Subject: Information Regarding the Underground Derived Waste Storage Plan

Underground Derived Waste Storage Plan, Revision 1

Responses to the New Mexico Environment Department
December 2, 2014, Comments on the Underground
Derived Waste Storage Plan

ATTACHMENT 1
DERIVED WASTE STORAGE AREAS

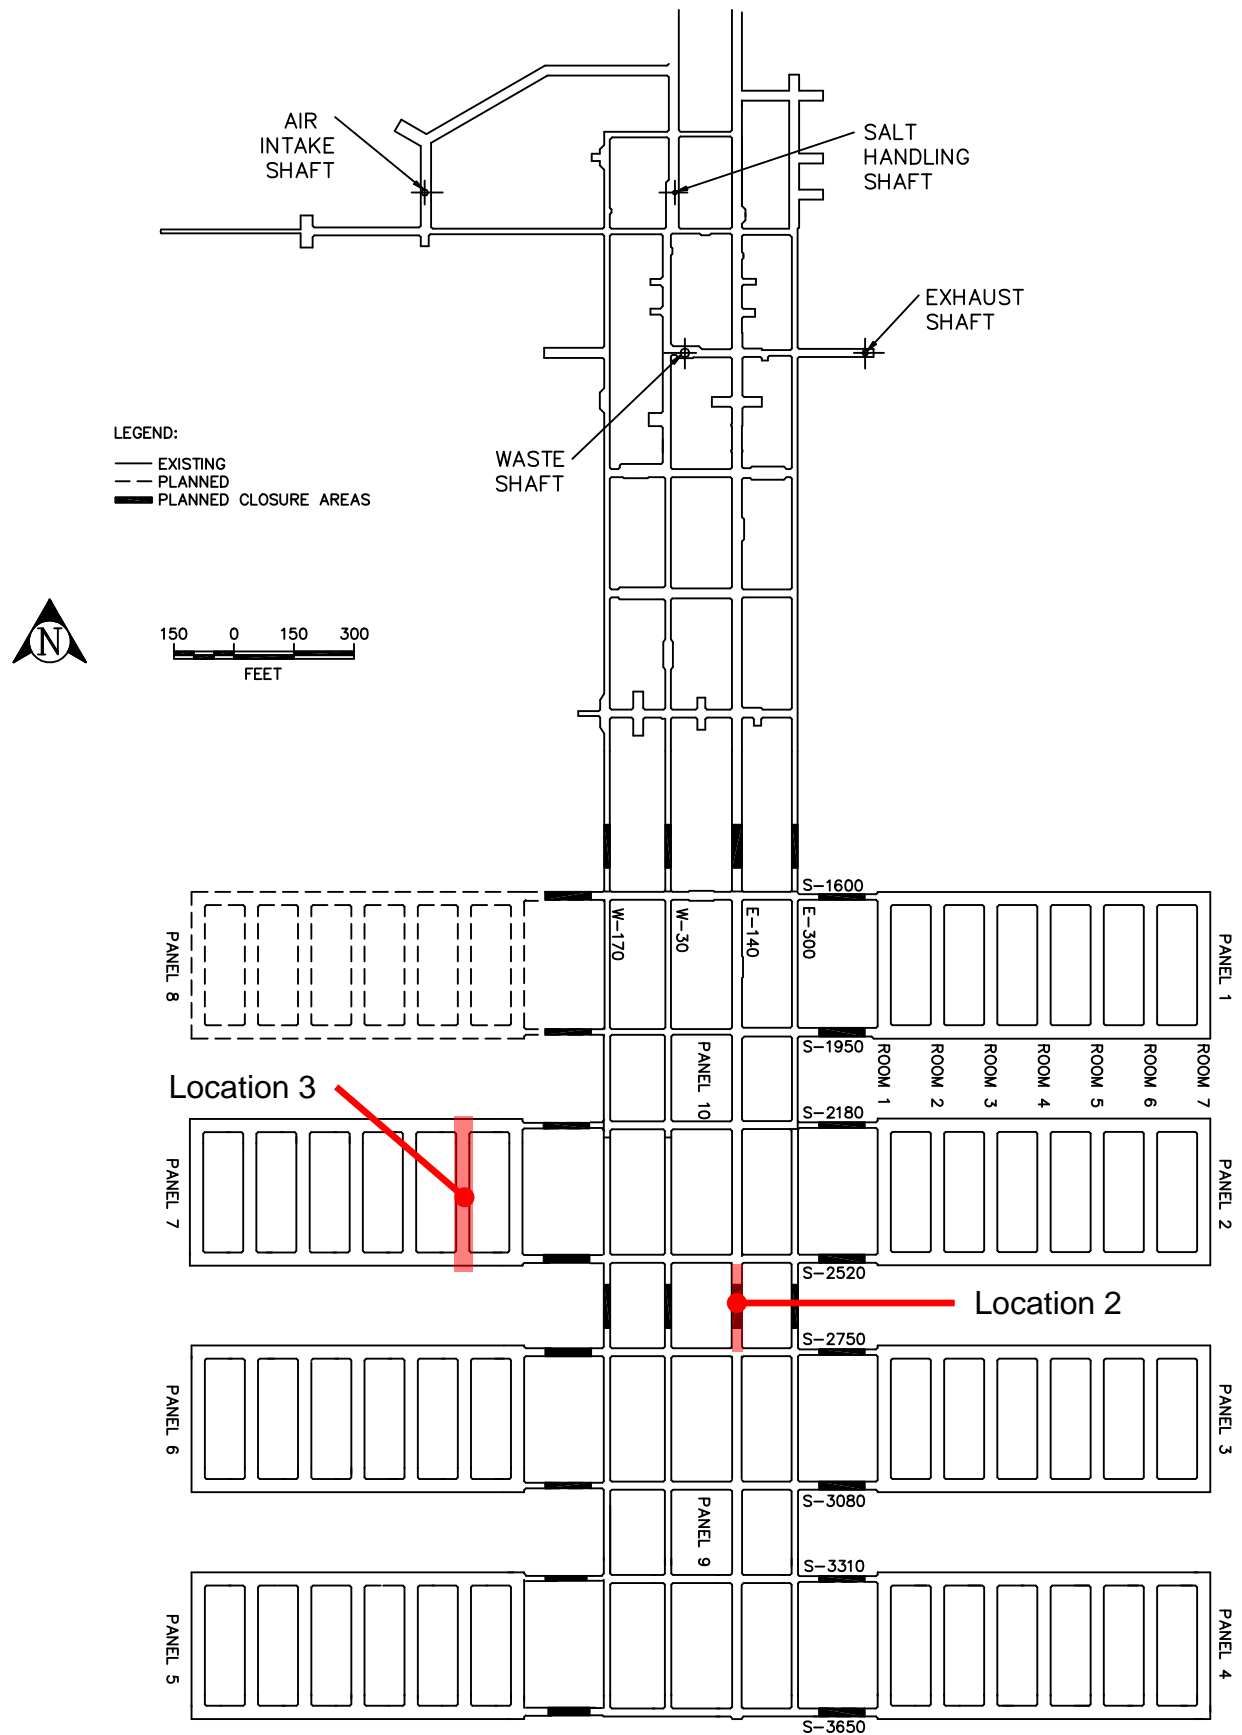
NMED Comment 16: *Attachment 1: Derived Waste Storage Areas. The Permittees shall provide nominal dimensions for these areas.*

Response: The nominal dimensions are as follows:

These nominal dimensions are included in the revised Underground Derived Waste Storage Plan.
